Joylebank

Bd. 10509
Elec. fittings Rpt

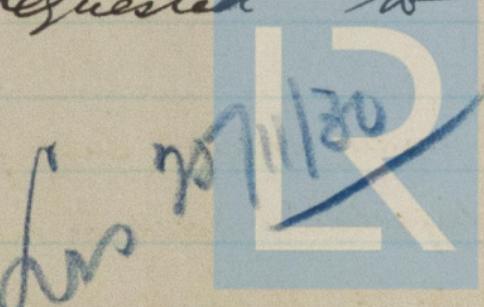
Generators, do they comply with the requirements
if not compound wound state distance between each generator

It is concluded that alternative
groups of lights are arranged in the
machinery space, but the surveyors
should be requested to confirm this
